Subject of Change

Parts Modification and Spec Upgrade

K6E12

K6E24

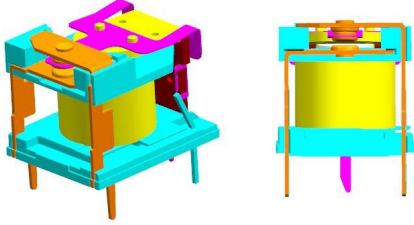
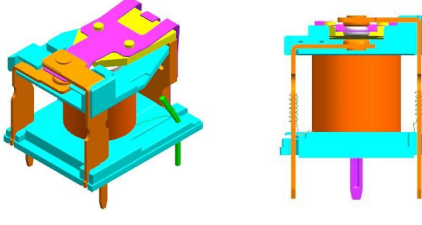
Before the change	After the change
Sealing method		
Sealing method changes from UV glue to hot stamp sealing		
Moveable contact spring, NC contact carrier and coil body		
Cancel the stand-off of the movable spring, and fix the movable spring by riveting instead of stand-off. Parts are changed for improved shock resistance.

Change to riveting for improved thermal conductivity
